CHINO 2045 GENERAL PLAN UPDATE
PROGRAM ENVIRONMENTAL IMPACT REPORT
(SCH #2024090833)

ERRATA

Chino 2045 General Plan Update Program Environmental Impact Report SCH #2024090833

This Errata has been prepared for the Final Program Environmental Impact Report (PEIR) to summarize changes since public review of Draft PEIR that began on June 20, 2025, and concluded on August 4, 2025. Changes were made to the Final PEIR both in response to comments received on the Draft PEIR and as minor changes initiated by City of Chino (City) staff to clarify or correct information the Chino 2045 General Plan Update (project). Changes made to the Final PEIR in response to comments received on the Draft PEIR are presented first, followed by a summary of changes to the text of General Plan Update elements initiated by City staff that did not result in changes to the Final PEIR.

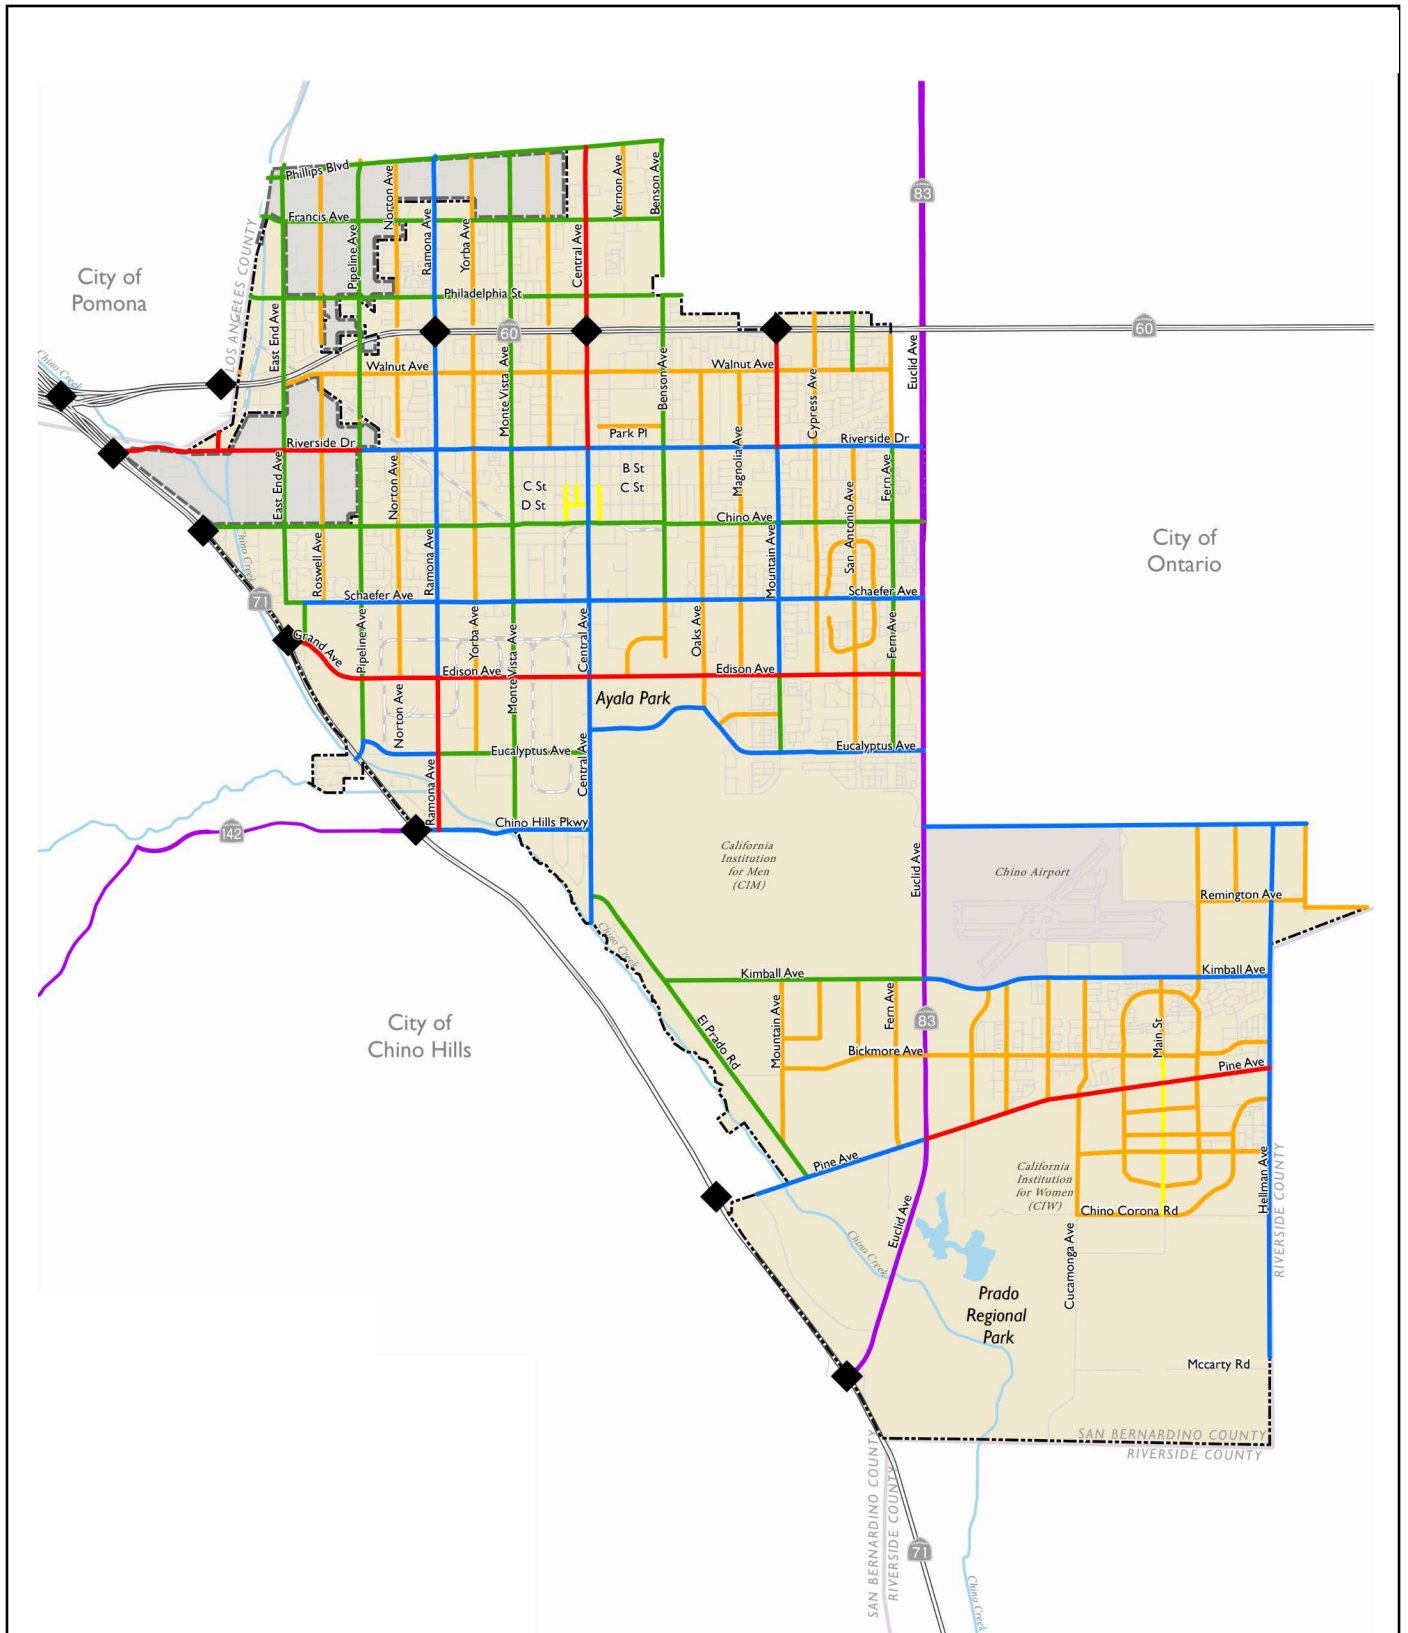
Figure 4.13-4 has been revised on page 4.13-21 to remove the designation of Flight Avenue between Kimball Avenue and Remington Avenue as a potential bicycle-truck point of conflict and renumber the subsequent potential bicycle-truck point of conflict. Figure 4.13-4 has also been revised to remove the proposed truck route designation from the segment of Philadelphia Street west of East End Avenue and to correctly present planned bicycle facilities consistent with the adopted Bicycle and Pedestrian Master Plan. See revised Figure 4.13-4 below.

FIGURE 4.13-1
Proposed Circulation Network

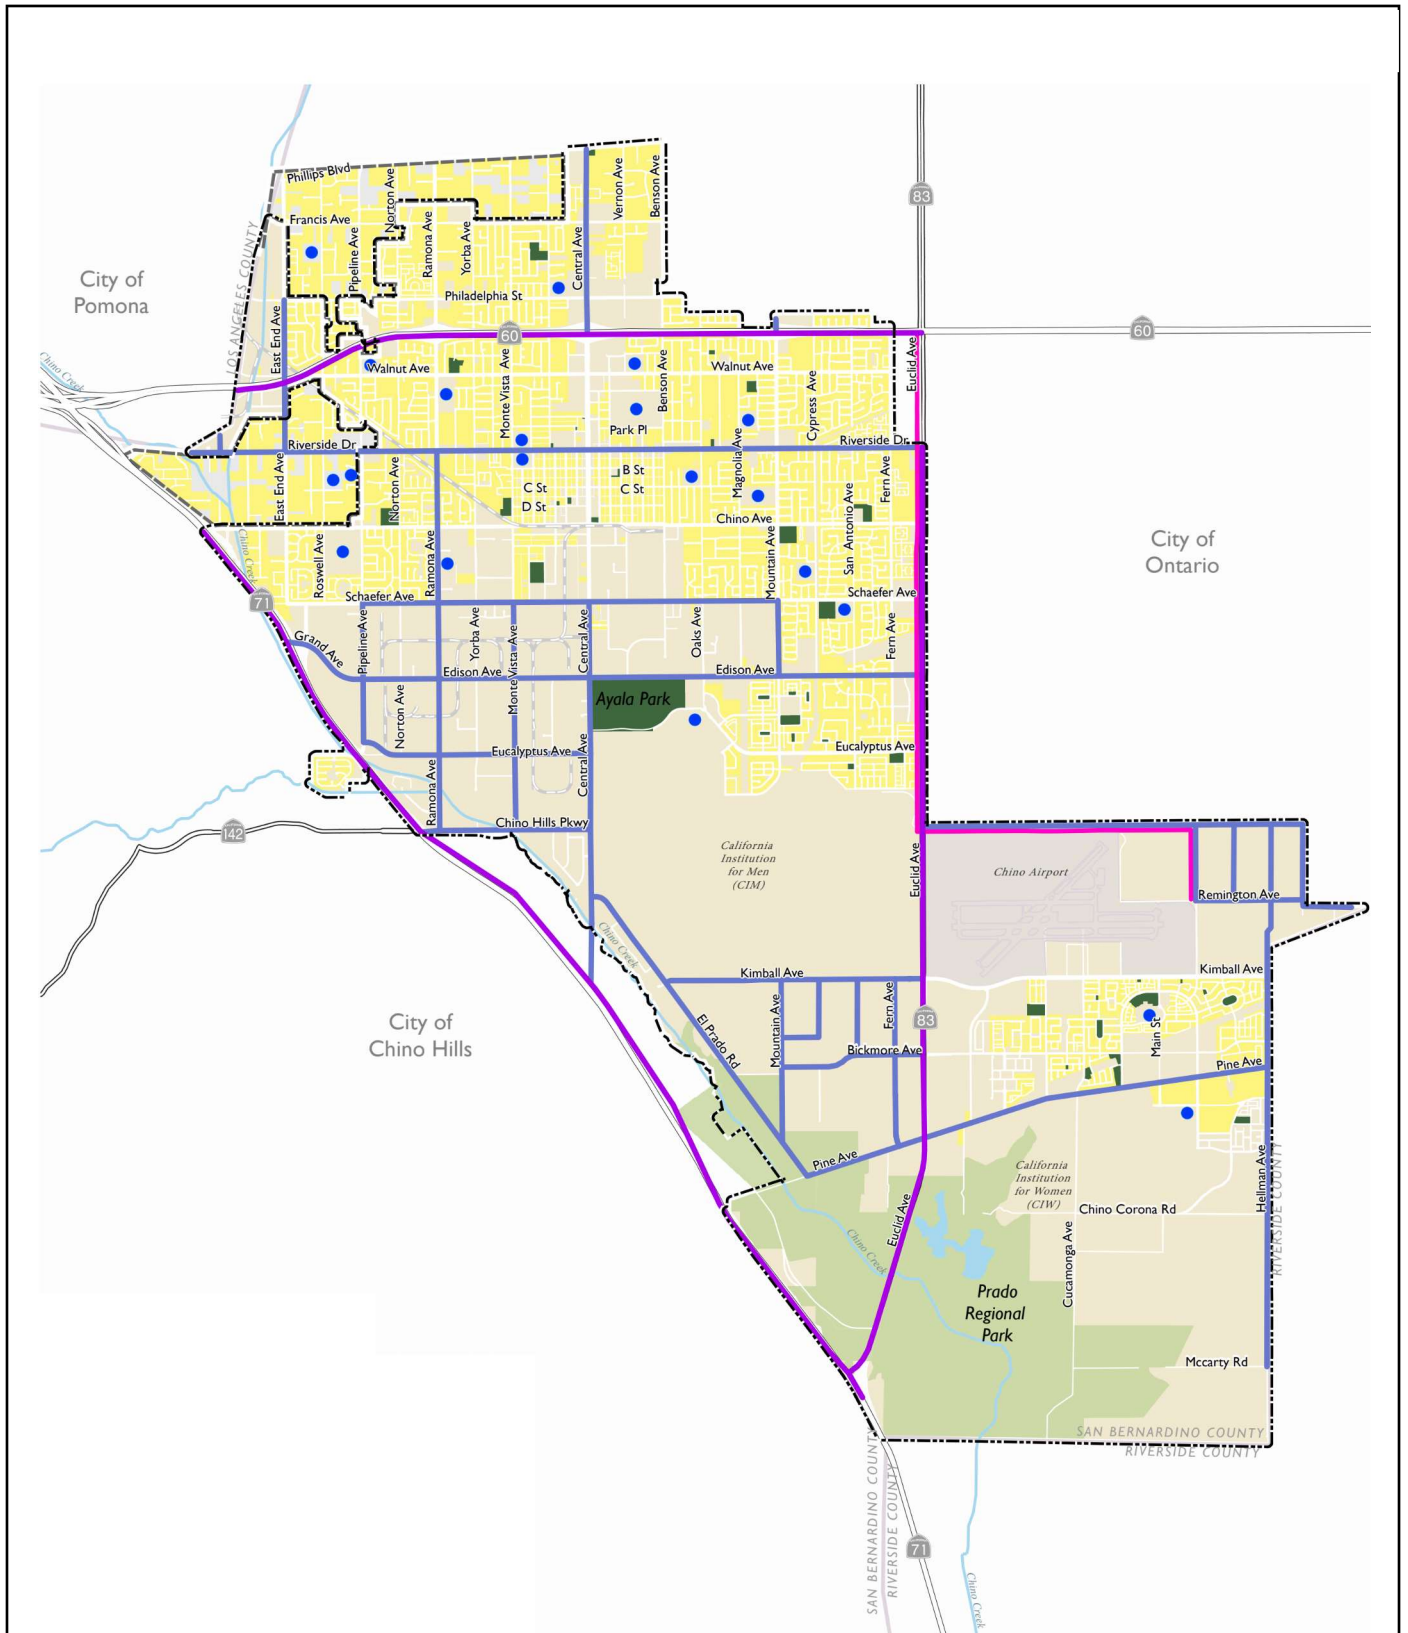
Figure 4.13-1 has been revised on page 4.13-2 to correctly present roadway classifications on the proposed circulation network. See revised Figure 4.13-1 below.

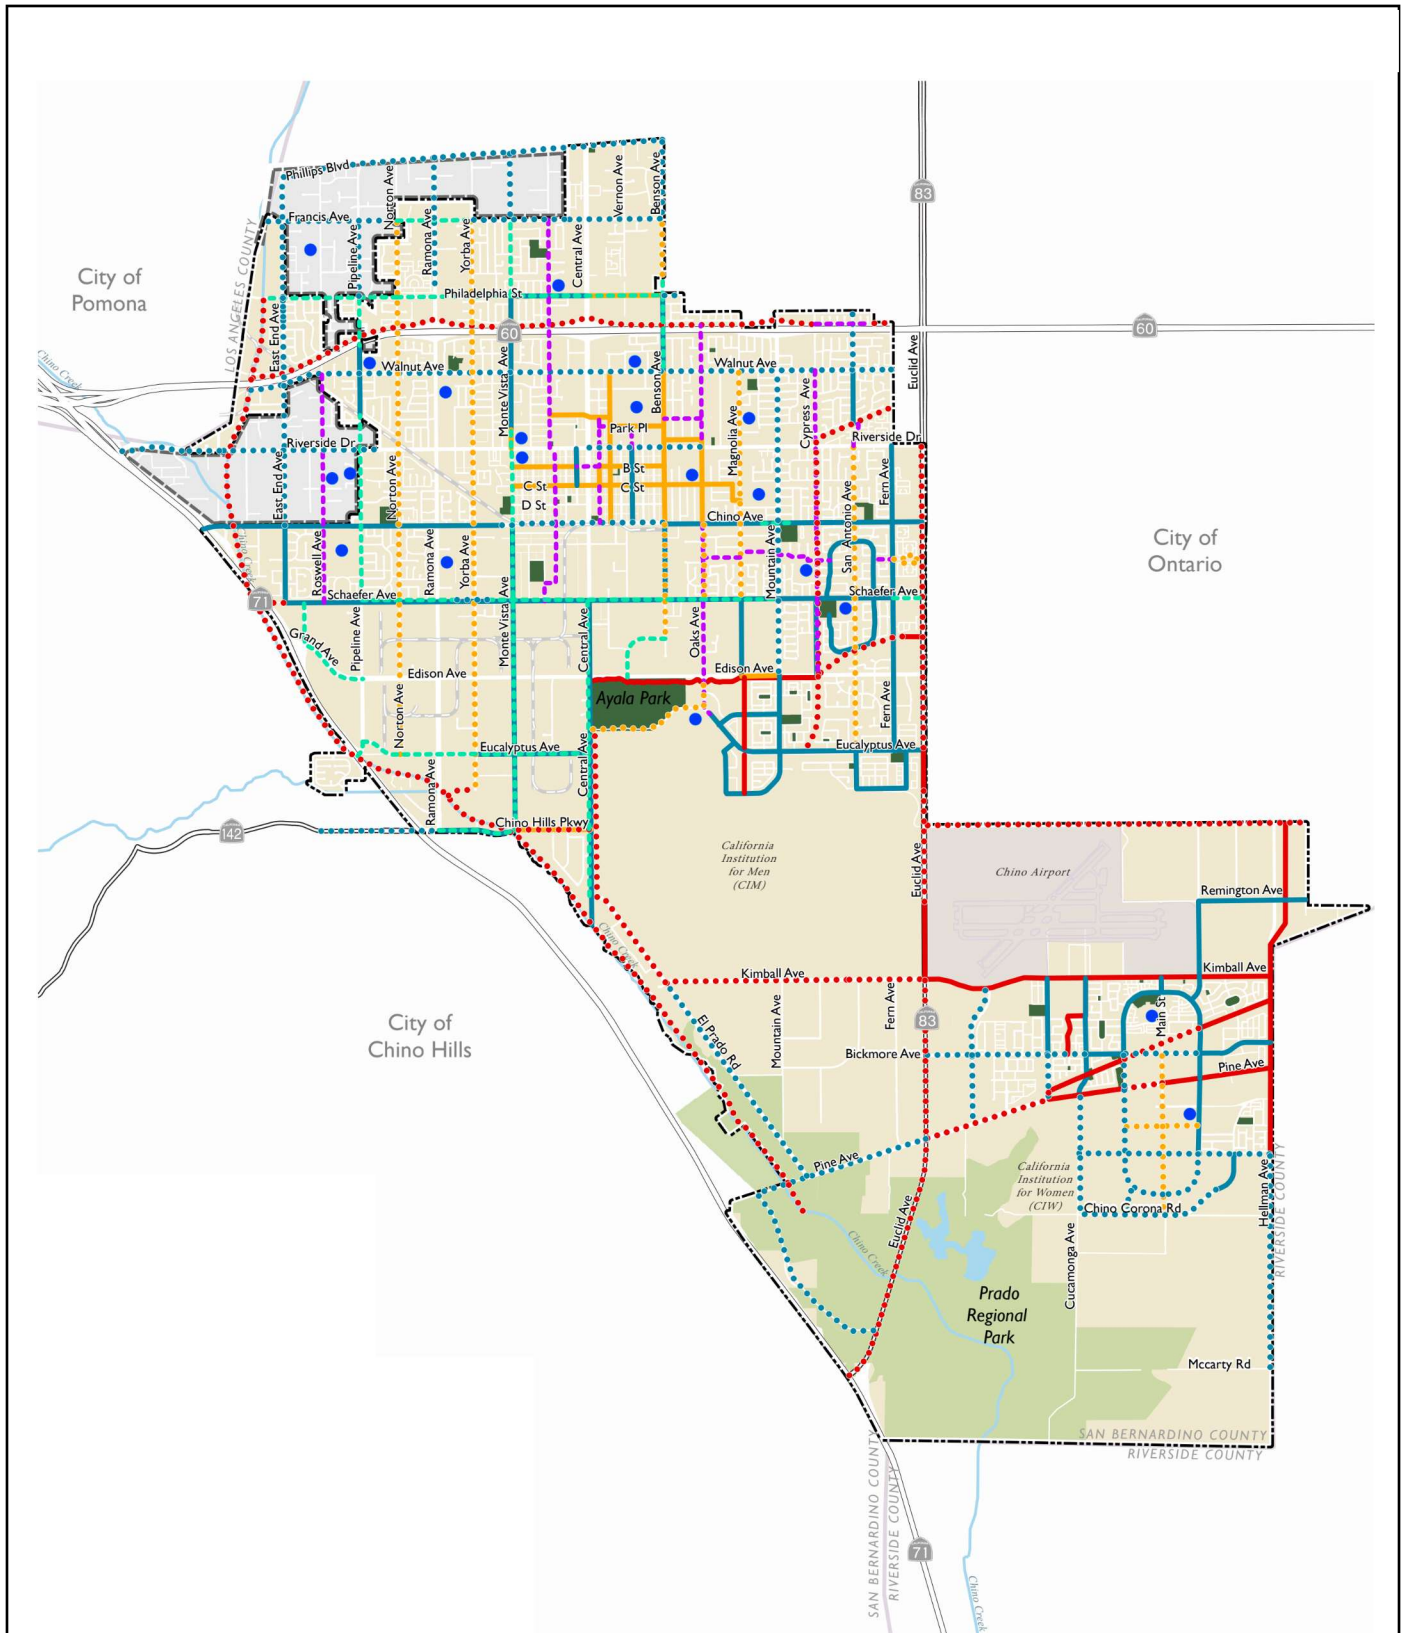
Figure 4.13-2 has been revised on page 4.13-5 to remove the proposed truck route designation from the segment of Philadelphia Street west of East End Avenue. See revised Figure 4.13-2 below.

FIGURE 4.13-3
Existing and Proposed Bicycle Network

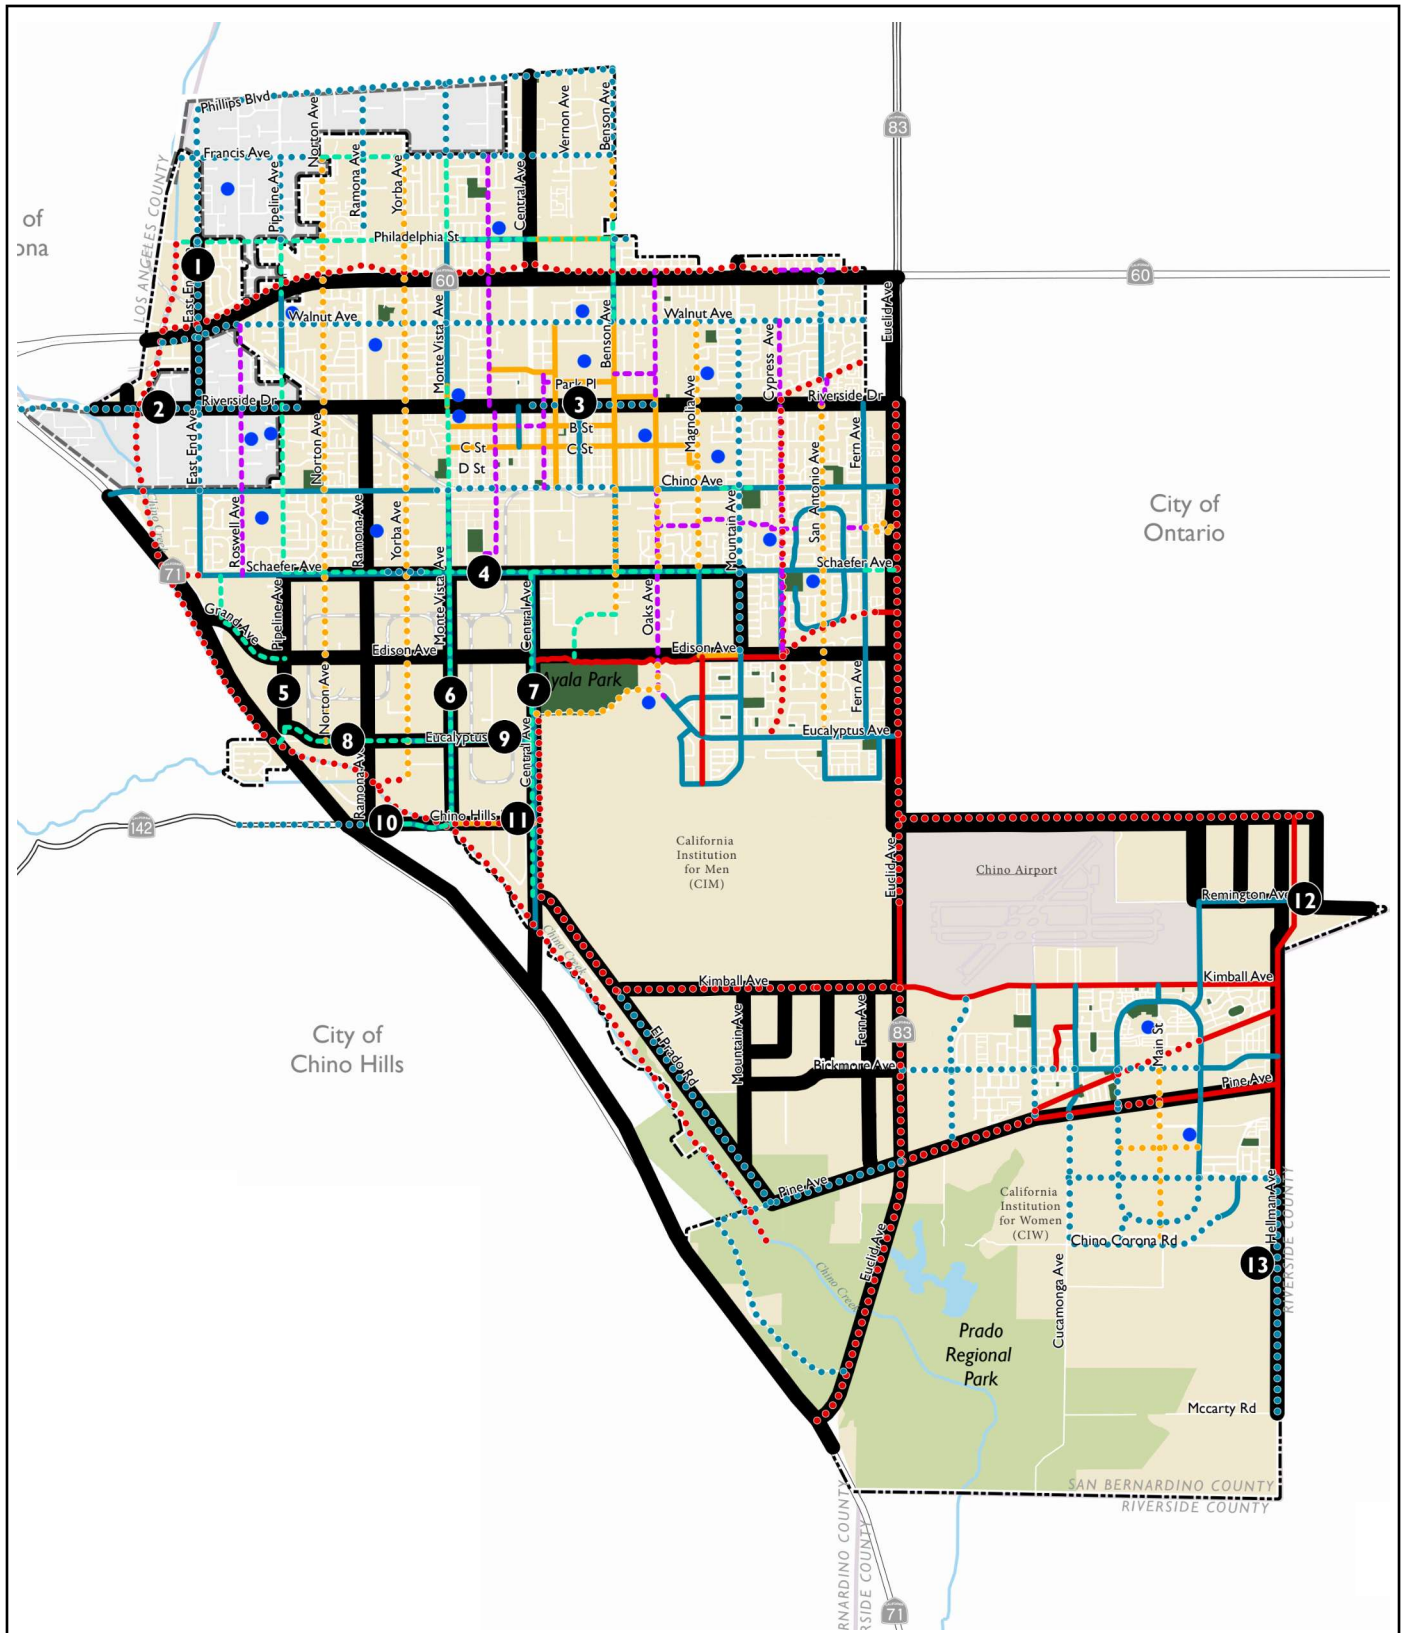
Figure 4.13-3 has been revised on page 4.13-7 to correctly present planned bicycle facilities consistent with the adopted Bicycle and Pedestrian Master Plan. See revised Figure 4.13-3 below.
